## FINAL ORDER

The Special Standards Request Form you submitted for owner: Port of Morrow, Start Card number 1056329; is hereby approved for the following: You may deepen and construct this well (MORR 52638) as described on your Special Standards Request Form dated May 10, 2022, and GSI Supporting Documentation dated February 28, 2022. *The stipulations for this Special Standard Request approval are:*

# Special Standards Request Form

### Port of Morrow Airport Well 3 Deepening

**AIRPORT WELL 3**  
Geology and Construction  
Elev: 367 ft

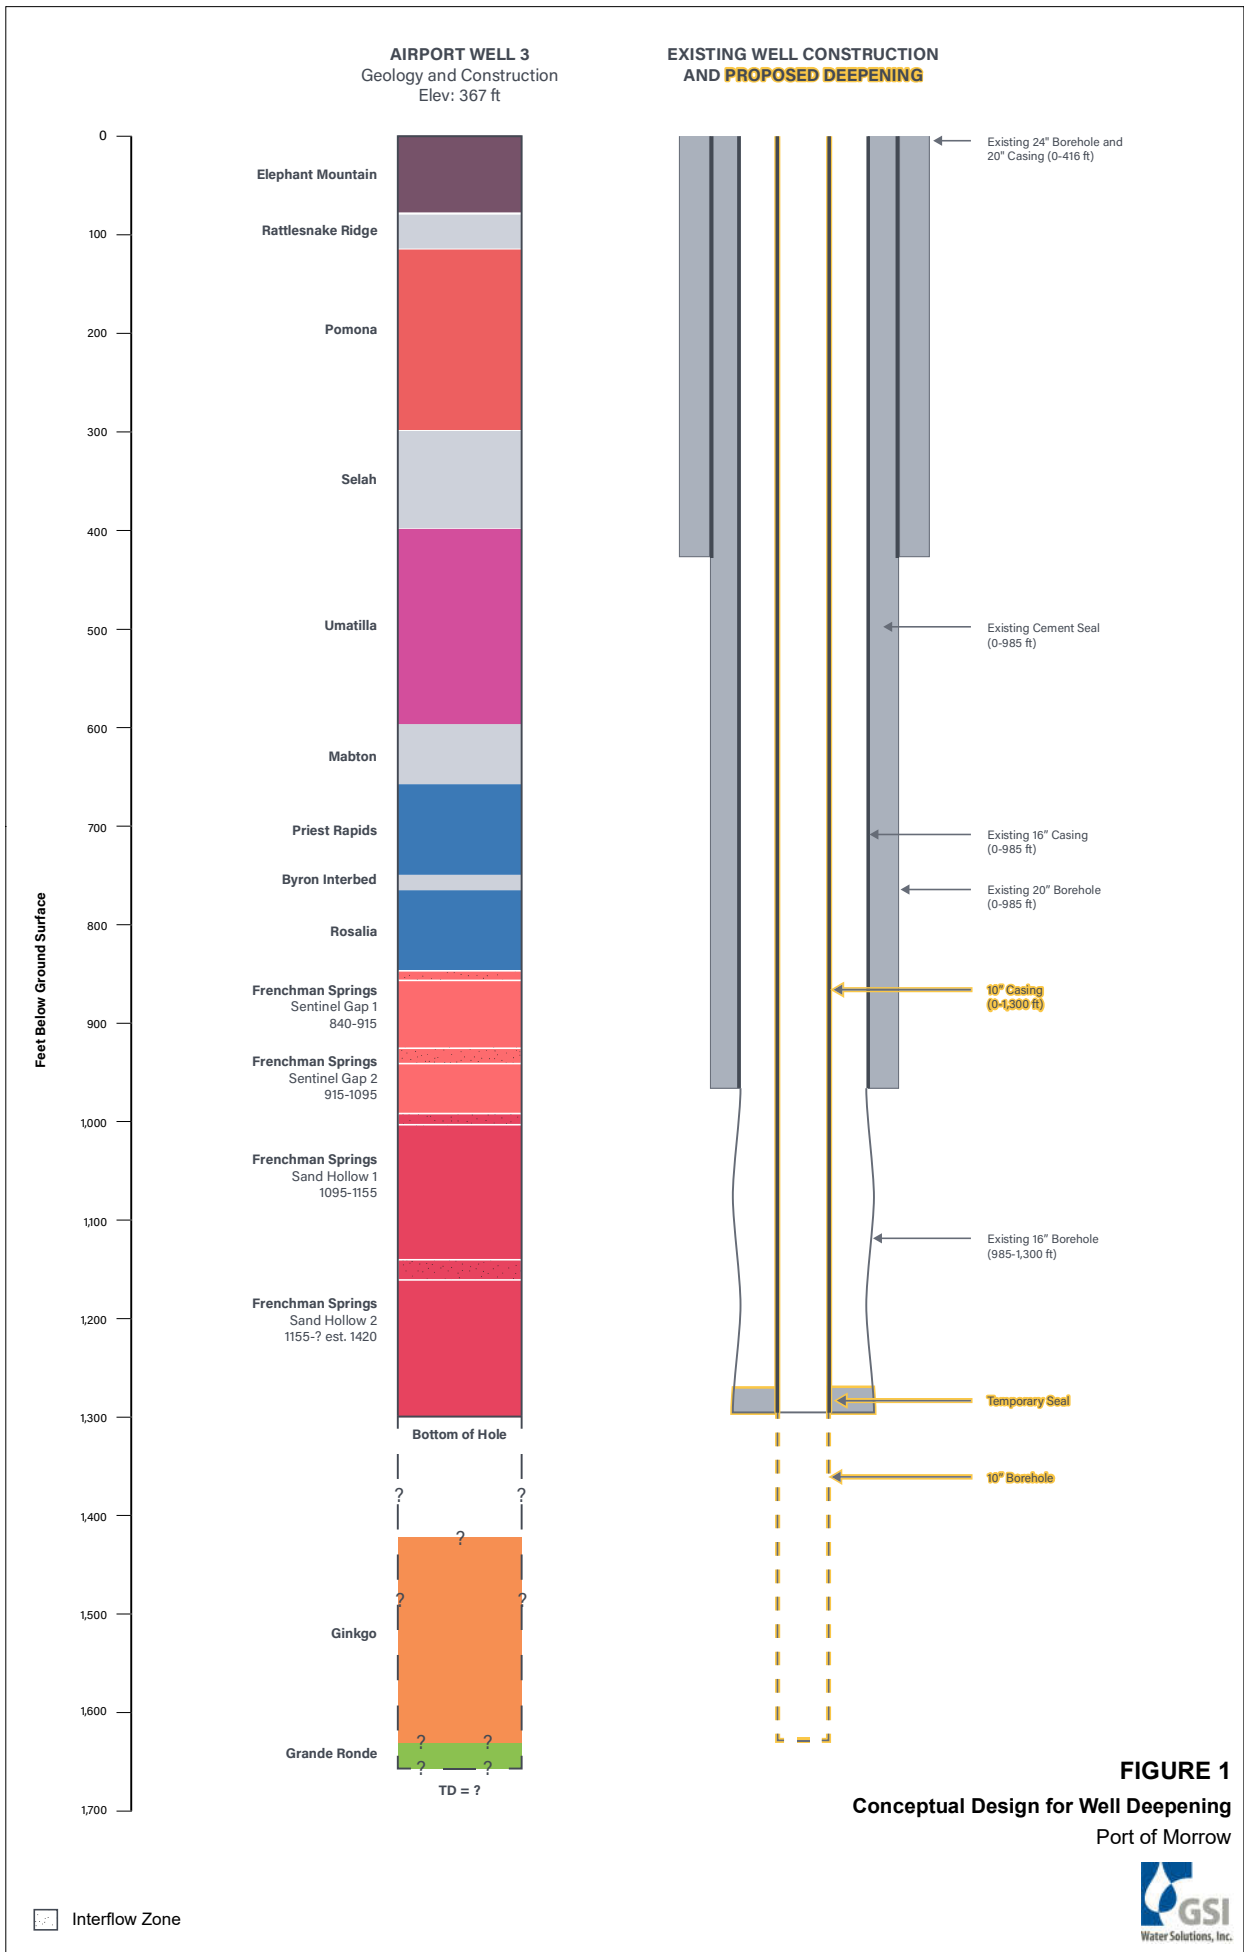
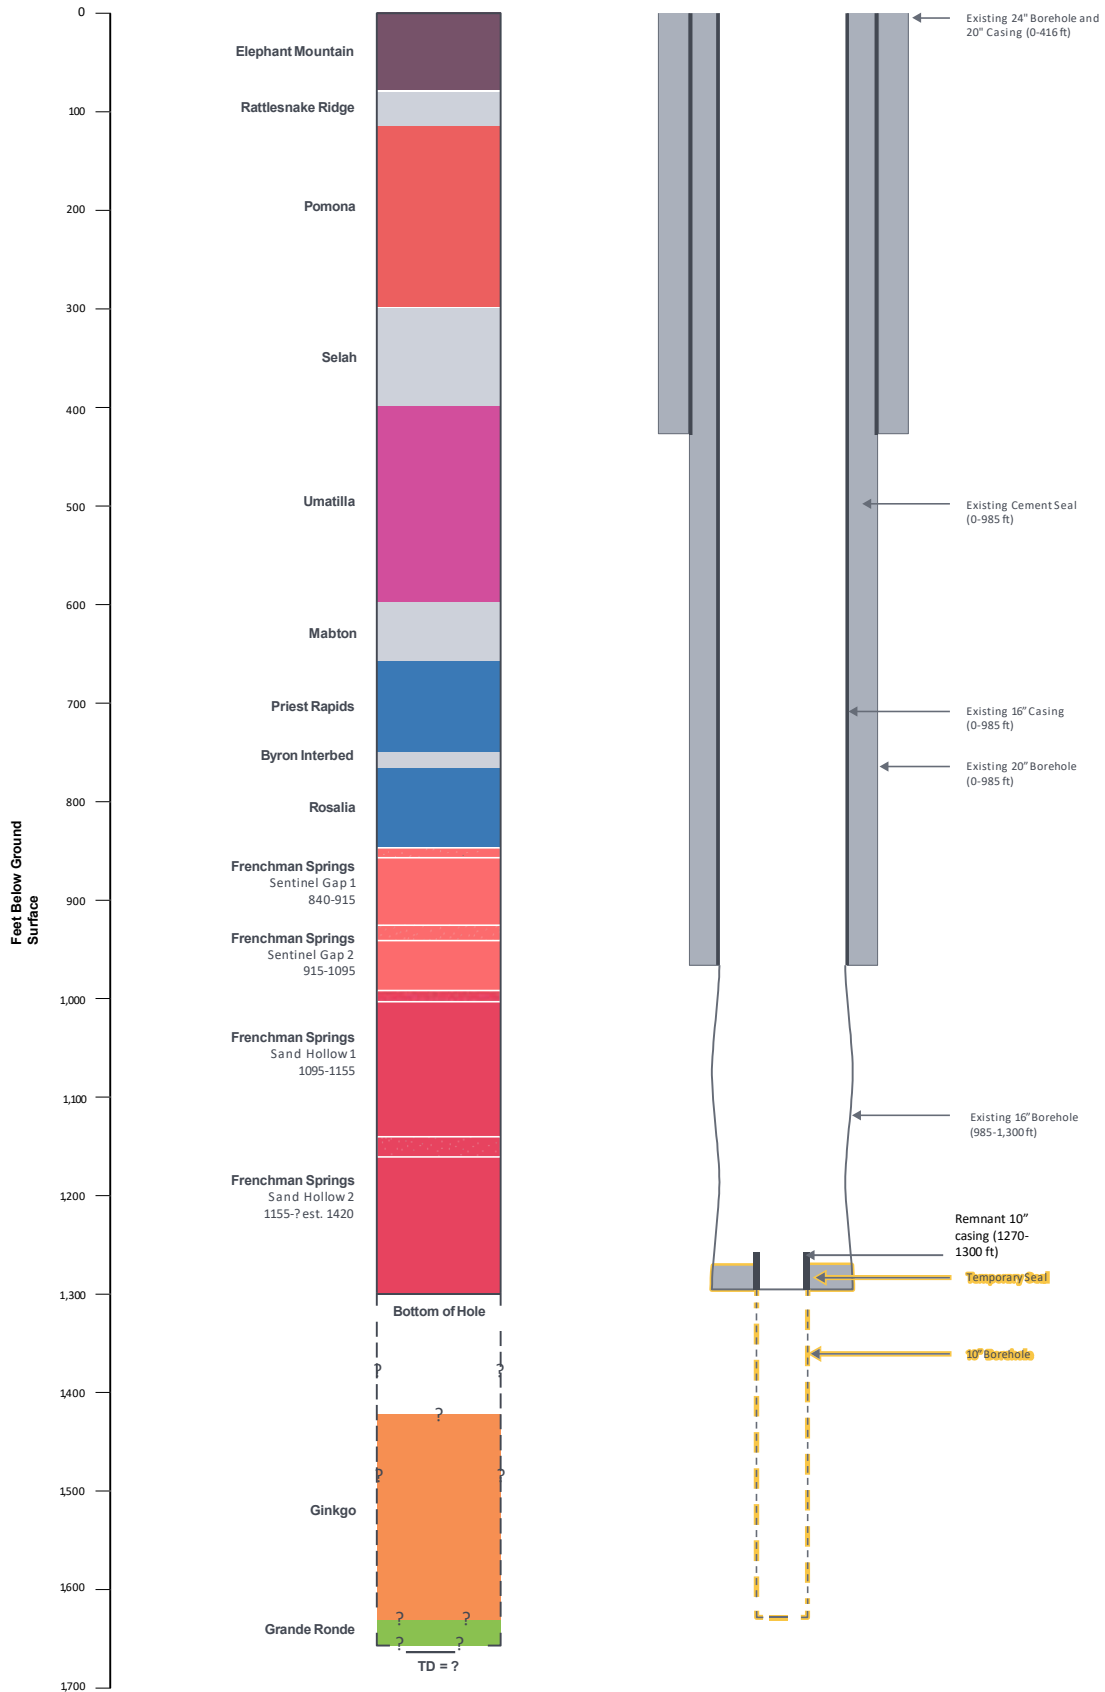
- *You must consult Tommy Laird, Well Construction Program Coordinator, prior to the final well construction decision.*
- *You must contact Tommy at least 10 days prior to beginning work on this well to indicate the construction schedule and an approximate date when consultation will be requested.*
- *You must have approval for the final well construction decision from the Oregon Water Resources Department prior to completing the well.*

- 1) If static water levels are similar between the Ginkgo and Sand Hollow flows within the Frenchman Springs Member of the Wanapum Formation (and OWRD is in agreement), then the production zone of the well will include both the Sand Hollow and the Ginkgo basalt flows. To accomplish this, the 10-inch casing will be cut above the split seal and removed to re-expose the Sand Hollow water bearing zones.

- 2) If static water levels are different, two scenarios may apply:
  - a) If the Sand Hollow is more productive than the Ginkgo, then the lower portion of the hole (below 1,300 feet bgs) will be abandoned. The 10-inch casing will be cut above the seal (at approximately 1,270 feet bgs) and removed to retain connection with the water-bearing zones of the Sand Hollow flows.

- b) If the Ginkgo is more productive than the Sand Hollow, then the 10-inch casing will be left in place and the seal will be completed (using Method C) between the 10-inch casing and 16-inch borehole/casing to an overlap of 10 feet or more inside the 16-inch casing.
